**ADDENDUM No. 1**

**Diablo Water District**

**Reservoir R-2 Foundation Seismic Improvements Project**

October 28, 2022

S-2

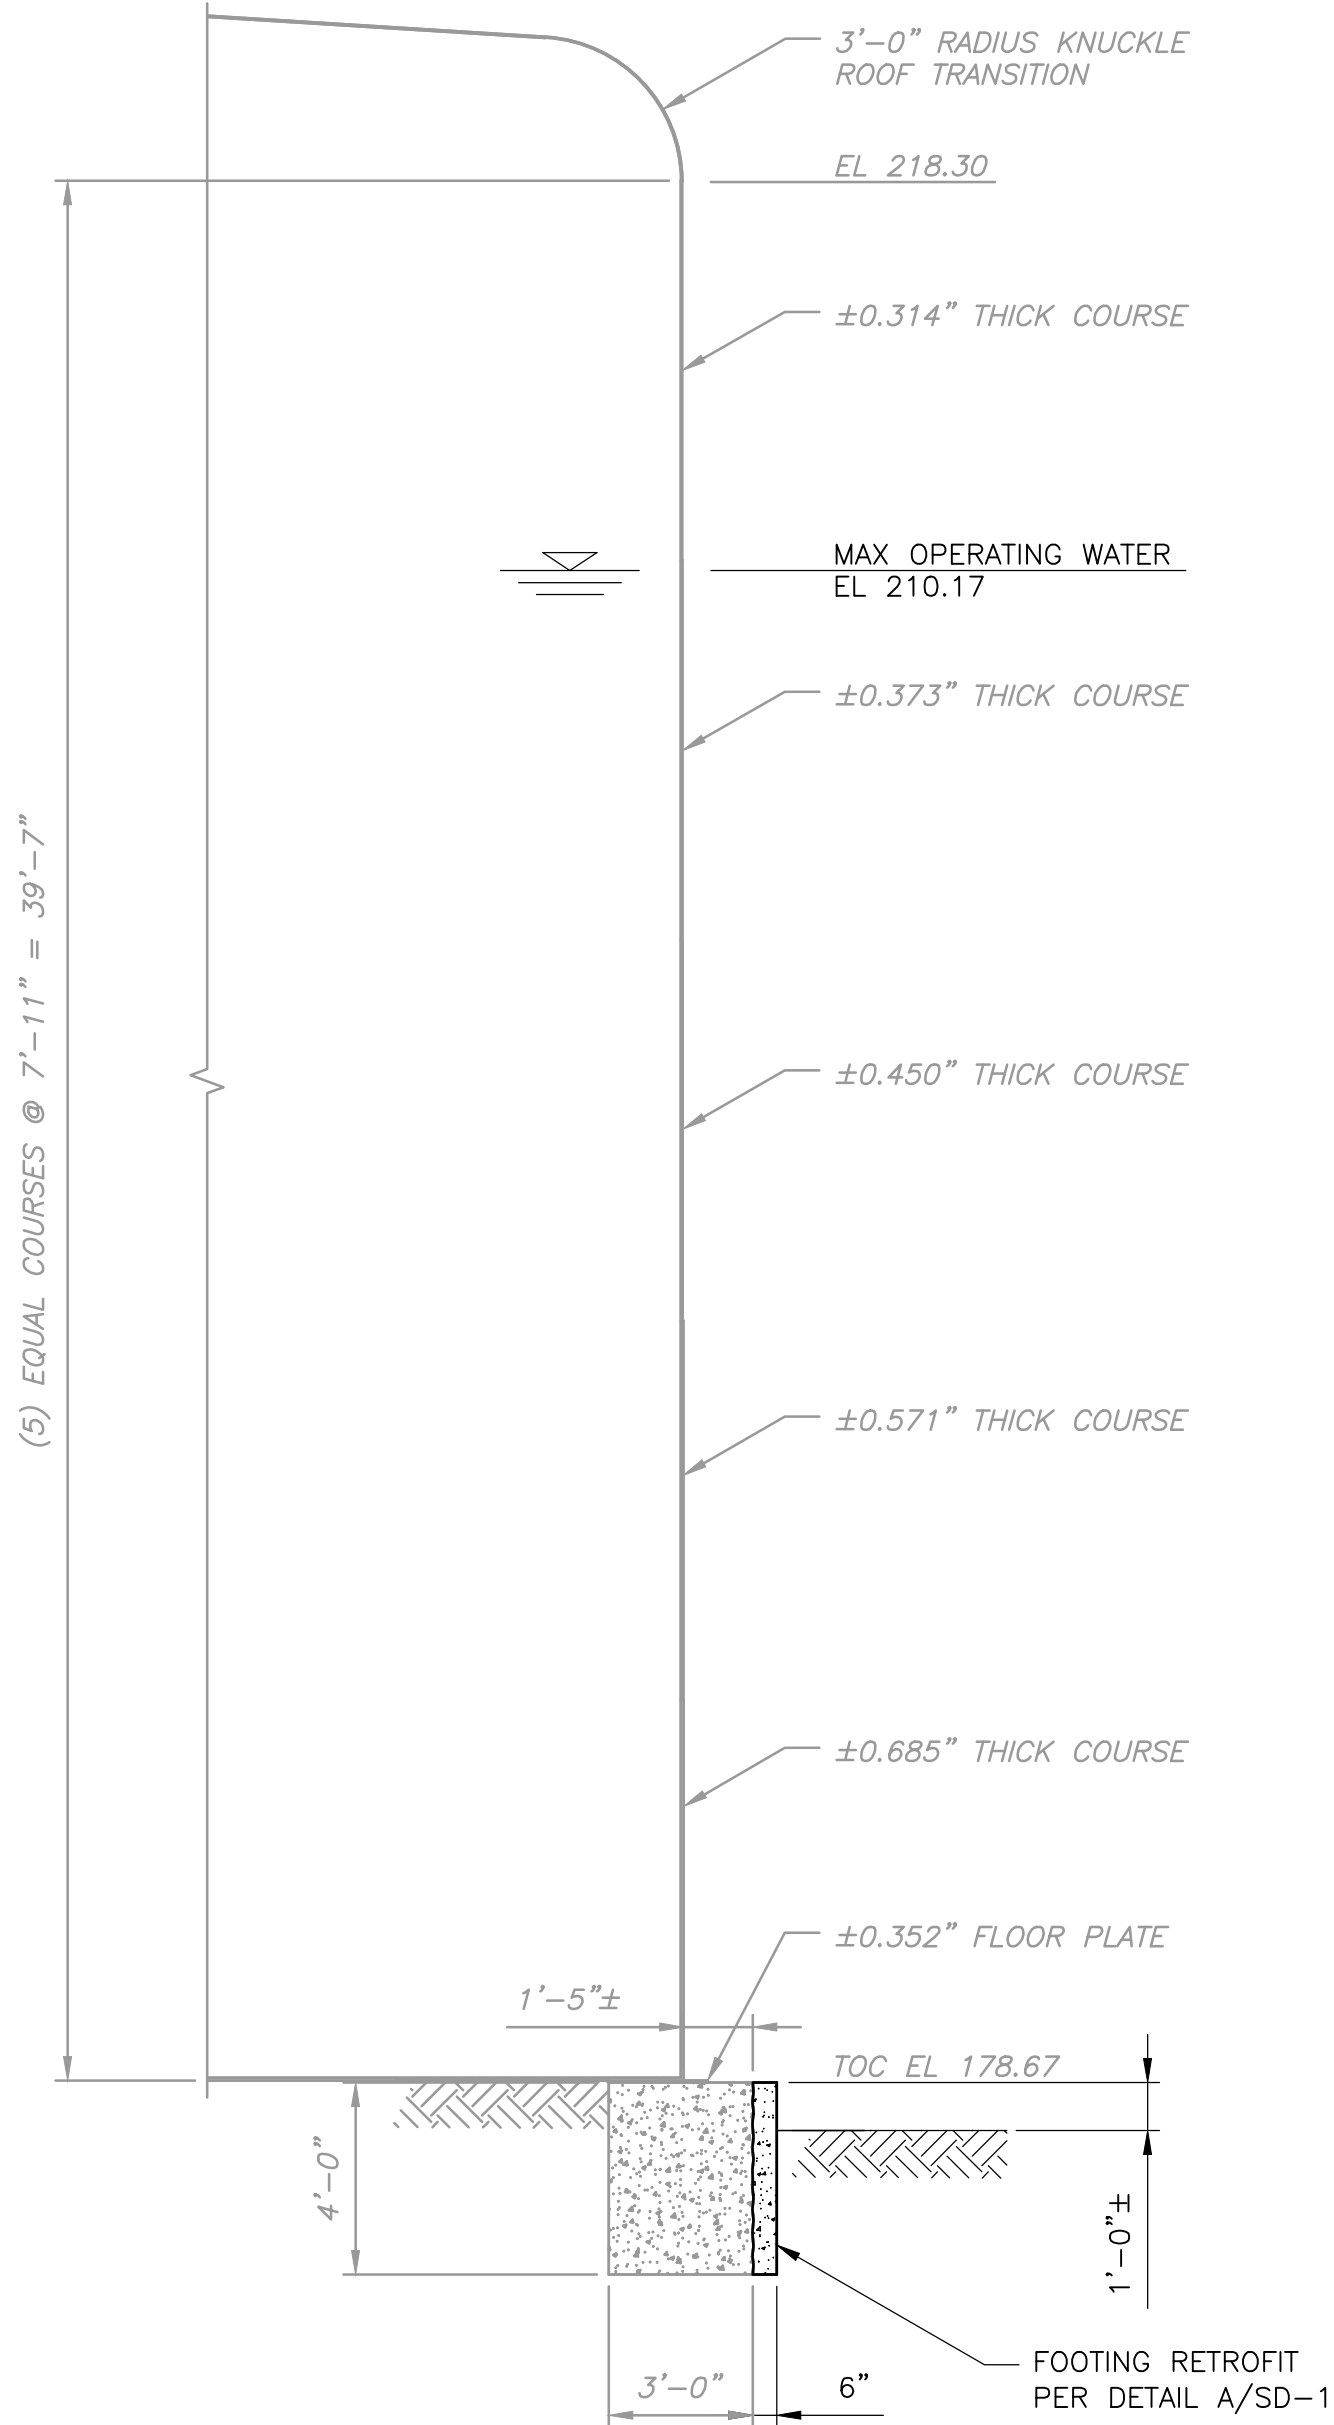
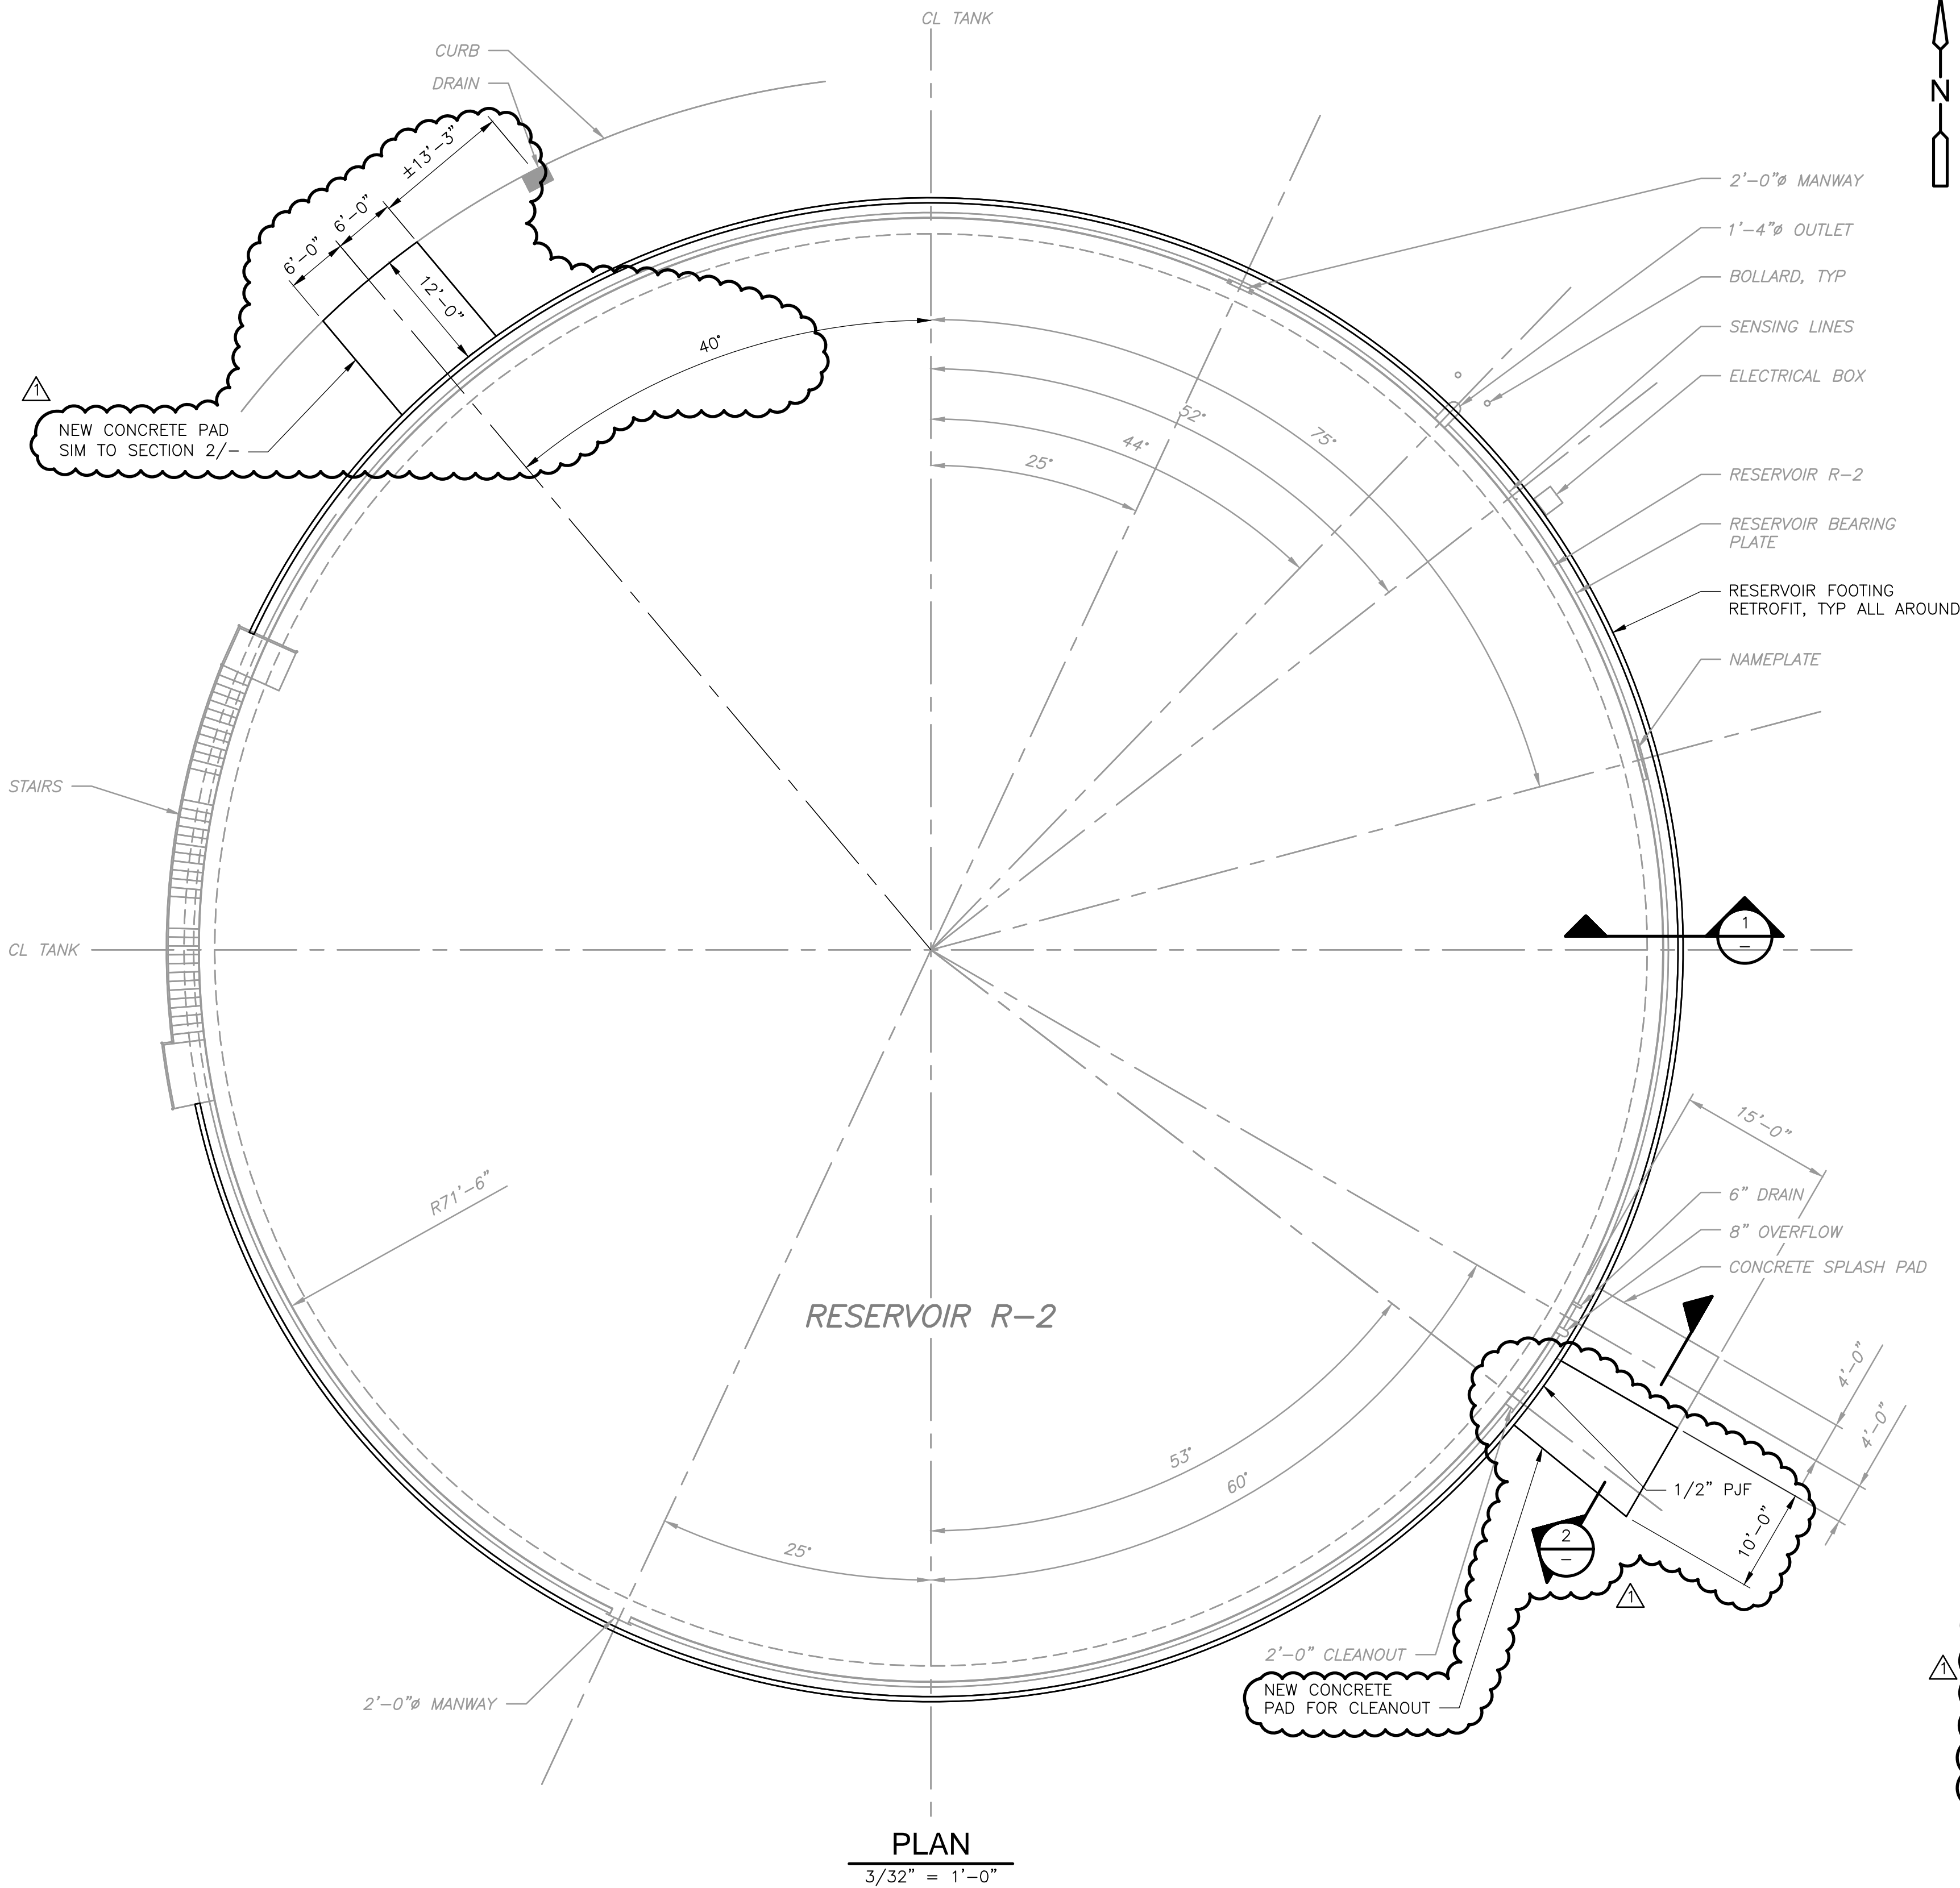
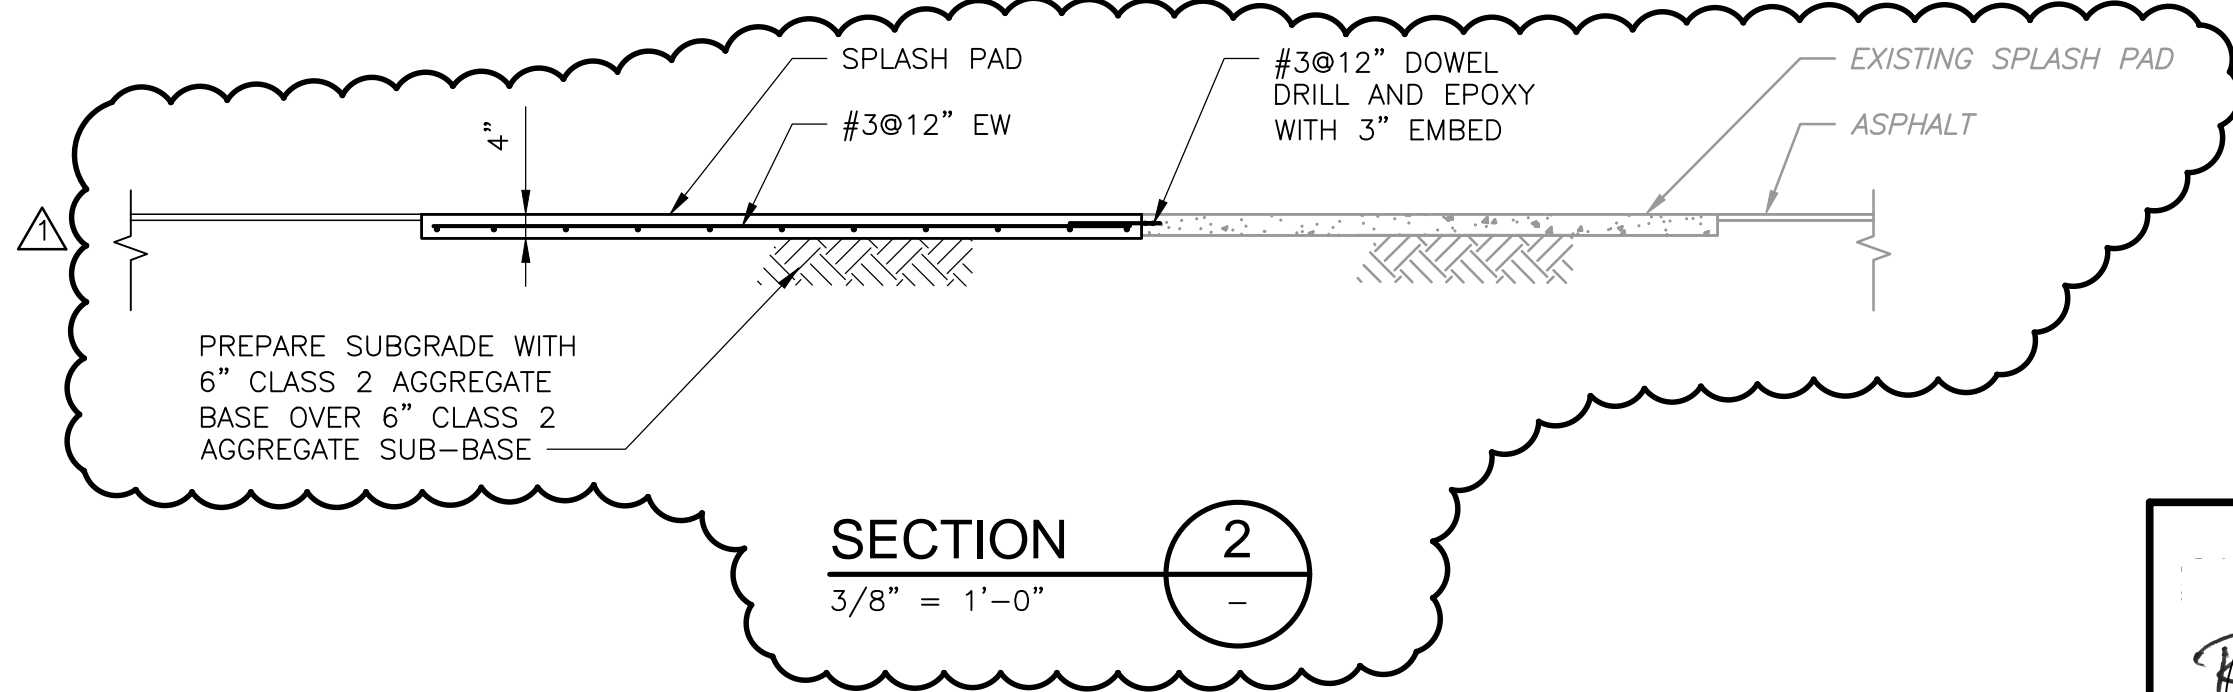
15. ***What is the thickness of the roadway structural section around the tank? Thickness of AC & thickness of CL II base are not noted on the plan set.***

The existing asphalt thickness is 3" and aggregate base is approximately 6". See Detail A on drawing SD-1 and Section 2 on drawing S-2.
